Electricity Analysis Office
Electricity Supply Analysis Division
California Energy Commission
Re: Docket No. 11-IEP-1D 1516

Clean Coalition comments on CEC Staff Paper: Proposed Method to Calculate the Amount of New Renewable Generation Required to Comply with Policy Goals

Kenneth Sahm White, Analyst for Clean Coalition
March 18, 2011

*Note: PG&E's total includes 1700GWh of space based solar, listed in graph in category "other". Source: CPUC RPS Approved Contracts Feb. 2011

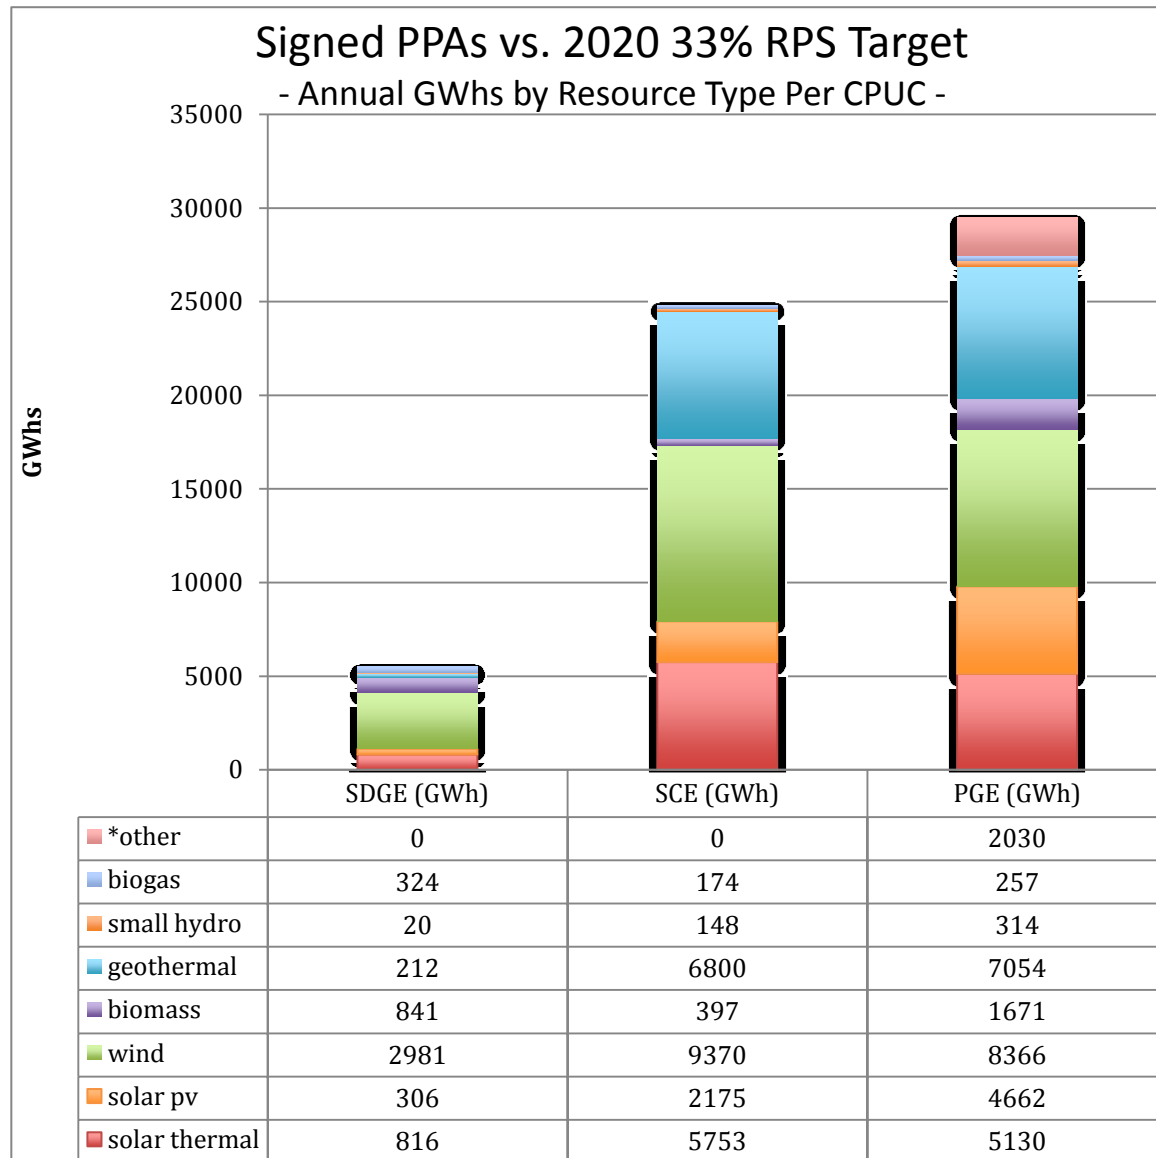
Solar thermal generation, in particular, faces significant risks, and plays a *large* role in IOUs plans to meet 33% RPS 2020 compliance. There are currently 5,067 MWs of permitted solar thermal generation projects with PPAs in development in California. Six of the major projects (representing 53% of capacity under contract) are located on federal land and are being sued regarding NEPA compliance.

The Clean Coalition requests that all data necessary to assess RPS Viability Risk be made available to Commission staff, and where possible, to the public. While some information is published regarding project development plans and schedules, the current CPUC RPS tables are an inadequate basis for assessment of RPS Viability Risk. Not only is project data difficult to compile, track, and compare, but the data itself often lacks meaningful accuracy – for example, until a project is withdrawn or has actually missed the COD deadline, it is listed as being "on schedule" regardless of actual project status. As a result, published RPS project viability estimates are highly unreliable and only measure relative probability of completion in any case. E3

conducted a risk assessment that discounted the RPS portfolio by 30%, a figure that, if accurate, has very large consequences for RNS estimates.

Additional data needs to be made available to CEC staff, and where possible to stakeholders and the public, in order to determine contract viability risk and reasonably assess the potential for contracted projects to contribute to RPS compliance schedules.
